Reading
BOROUGH COUNCIL

RE: Planning Application 01/01151/FUL 47-55 Westwood Road.

47 – 55 Westwood Road, Tilehurst – Planning Permission No. 01/01551/FUL
Re: Method Statements for Remedial Works to Plot 5 and Removal of BT Duct

776 – 102A

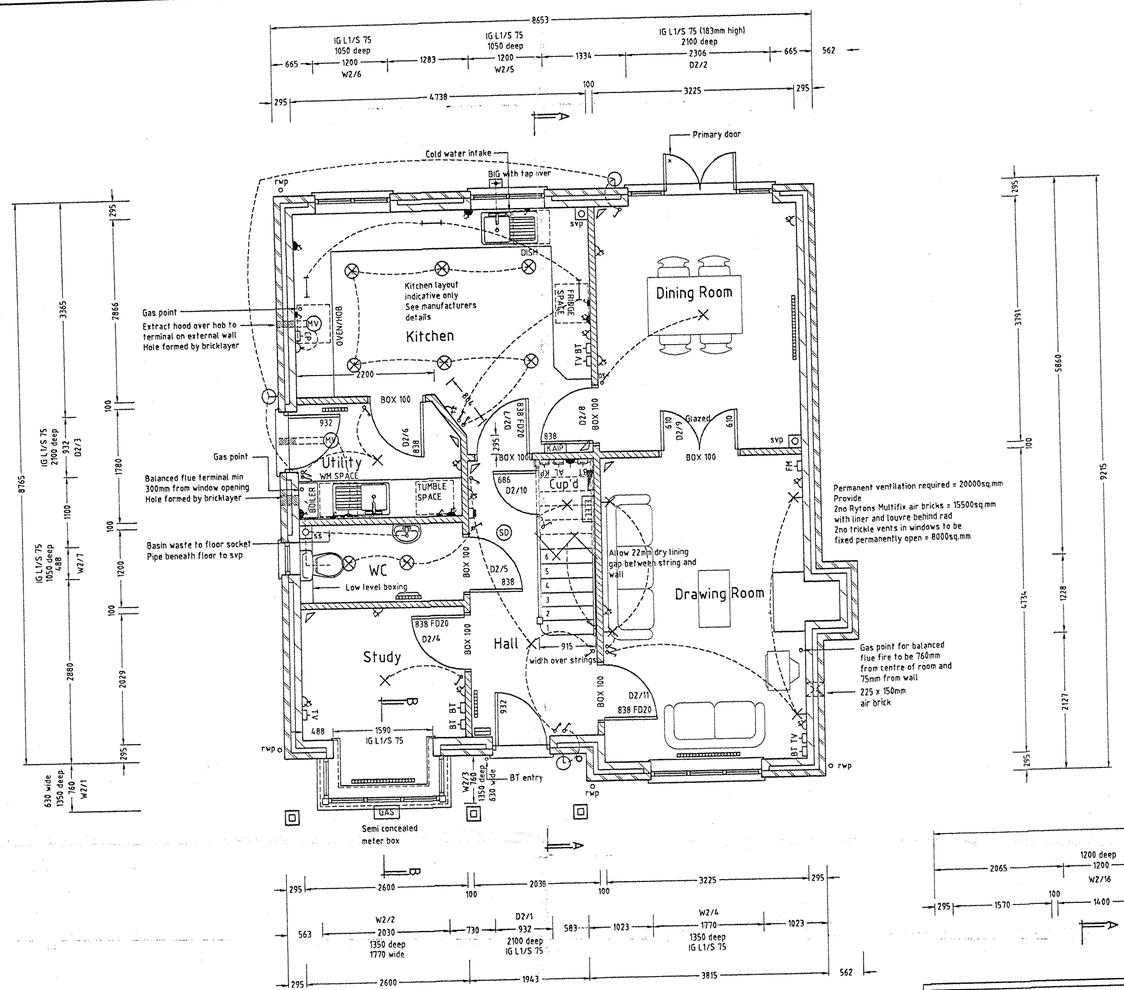
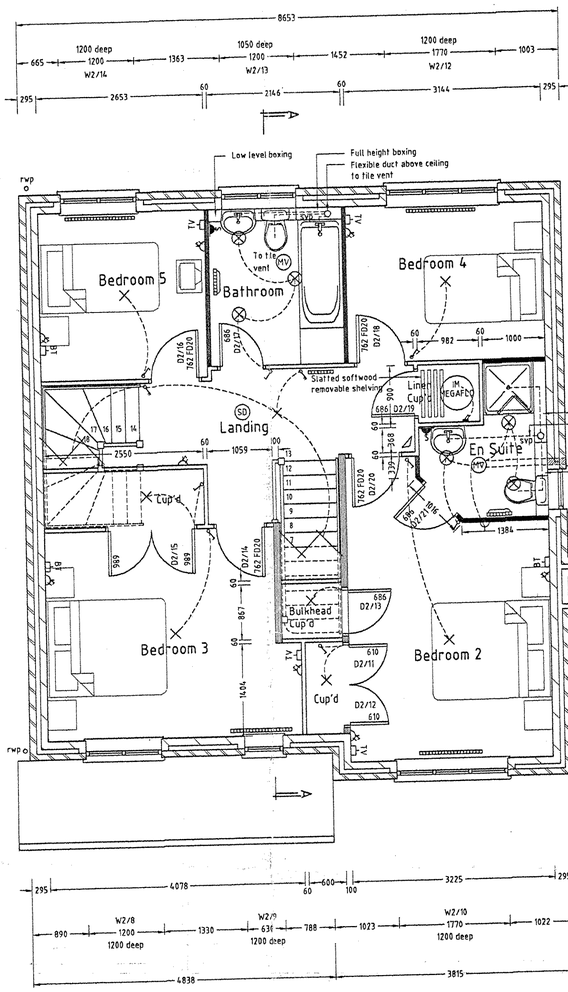
With reference to Landscape plan No. 776-102A, I have the following comments:

- There are some plant labels on the plan that are not included in the key – CR, HGM, PR, PTH. The plan therefore need amending to include the correct labels.

- Grass strip to north of access road – further shrub planting should be incorporated in this area
- Shrub bed to south of Plot 1 drive – there is no indication of the proposed species in this area.

- Planting is proposed under the canopy of TPO beech tree at the rear of 47 Westwood Road. Extreme care needs to be taken when planting in this area to minimise the damage to the roots of the tree.
